TURNER SENIOR ACADEMY CAMPUS

ADDENDUM 3

10/25/2023

OVER **EXCAVATION EXHIBIT**

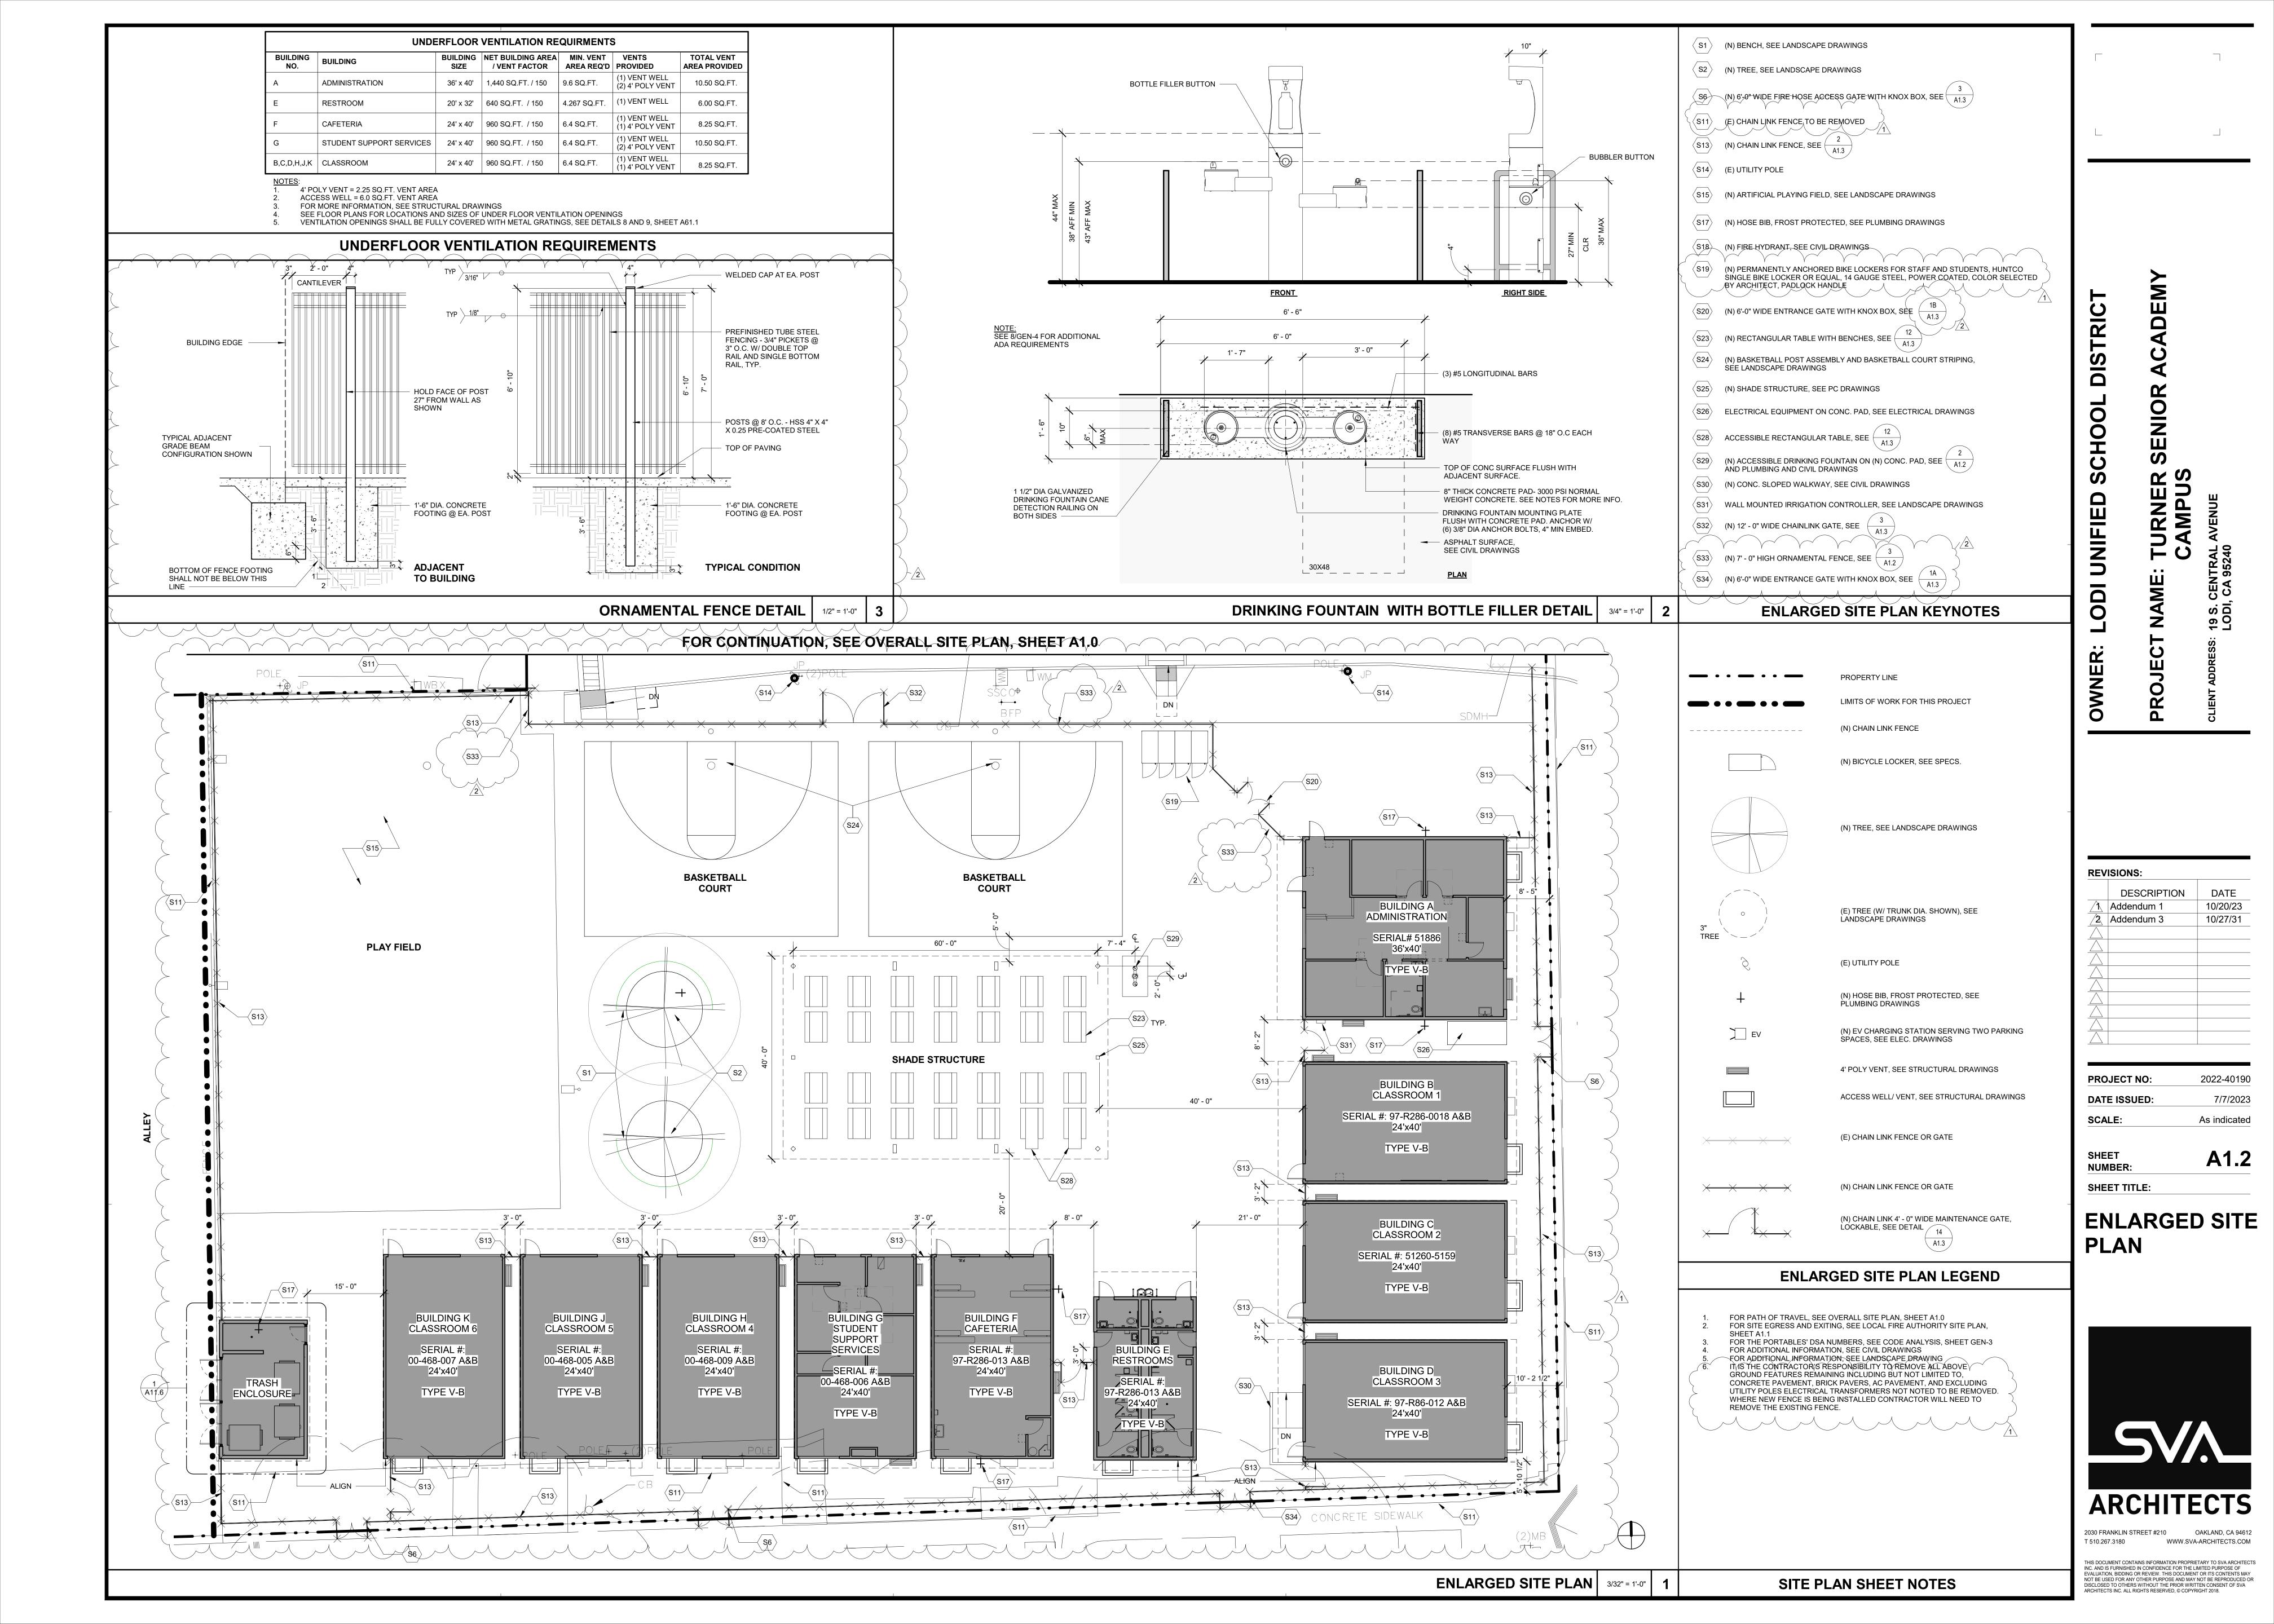
- A. EX1: Over Excavation Exhibit
  - a. Add sheet EX1, Over Excavation Exhibit, showing the extent of over excavation required.

A1.3

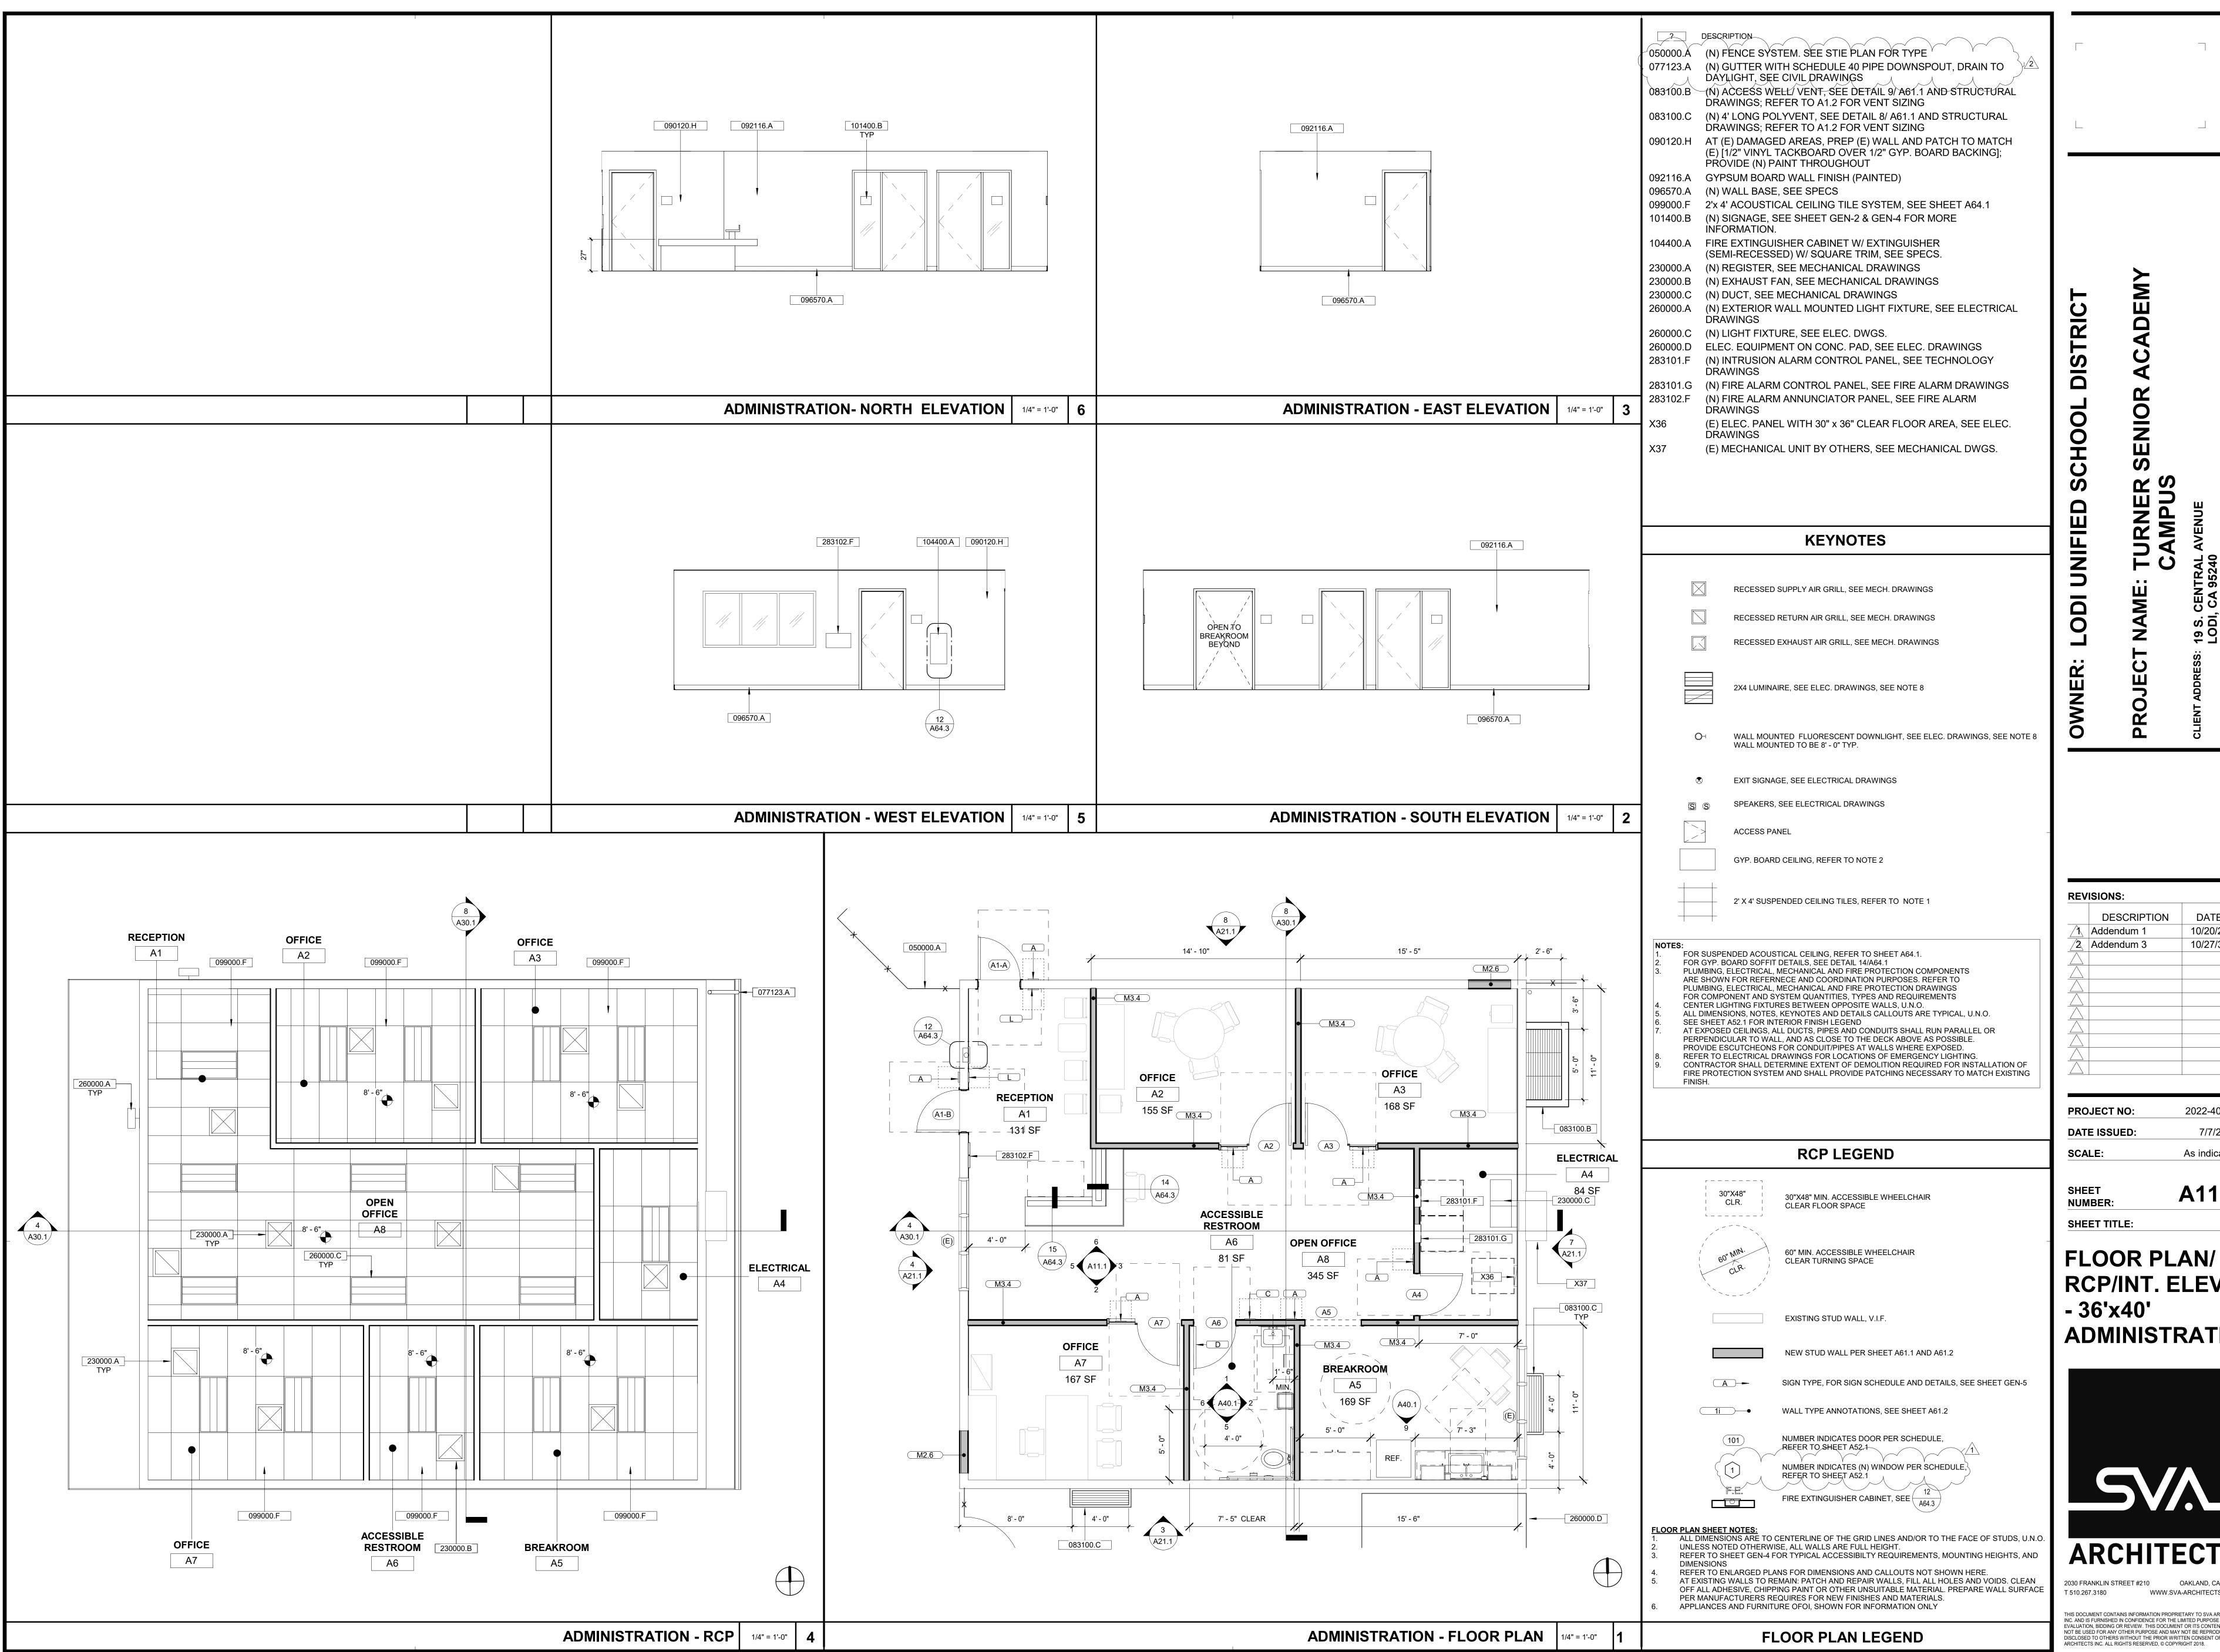
- b. Added Ornamental Fence Detail (detail 3)
- B. A1.3: Site Details (replace previously issued sheet)
  - a. Revised detail 1 (Entrance Gate Pair (Hardware Group 8) to show the condition at chain link fence and at the ornamental fence

- b. Revised detail 2 (Chain Link Mesh Fencing) to show all new fence components, included mesh, to be galvanized, and the height of the fence to be 7'-0".

A11.1

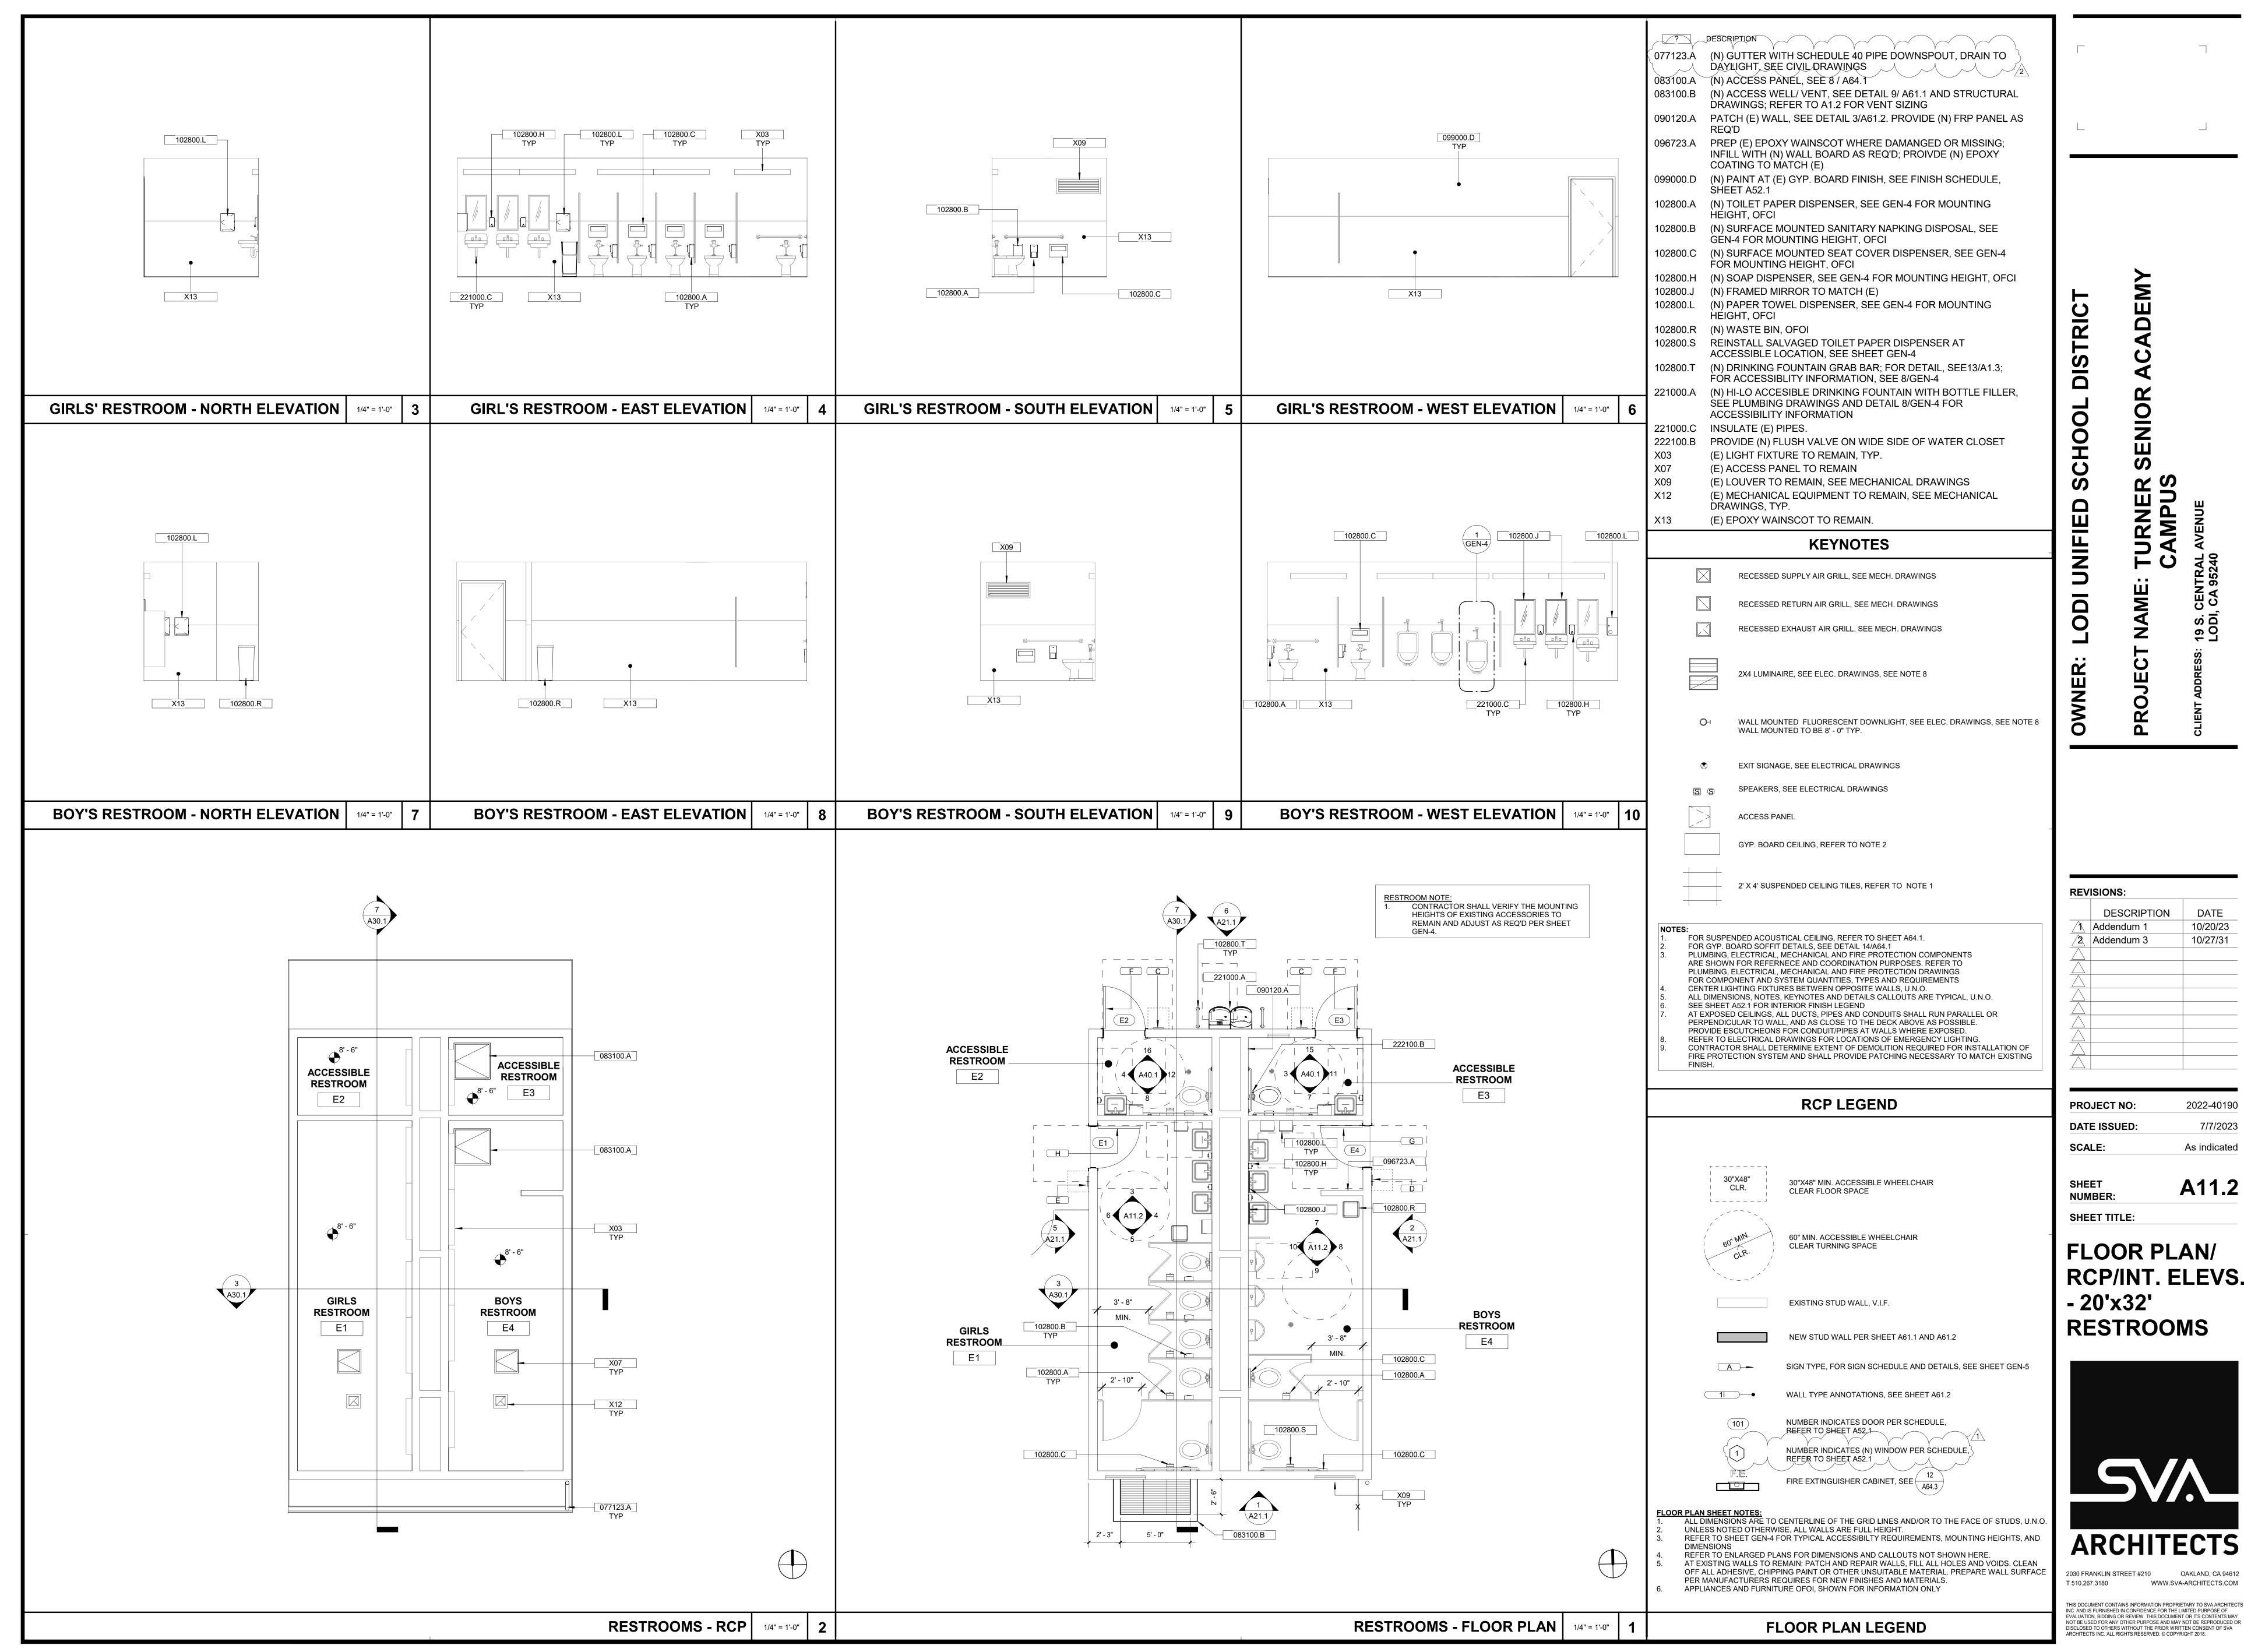
- C. A11.1: Floor Plan/RCP/Int. Elevs 36'x40' Administration (replace previously issued sheet)
  - a. Revised Keynote 077123.A to remove reference to connecting downspout to storm water system

- b. Revised Keynote 050000.A to reference Site Plan for fence type
- D. A11.2: Floor Plan/RCP/Int. Elevs 20'x32' Restrooms (replace previously issued sheet)
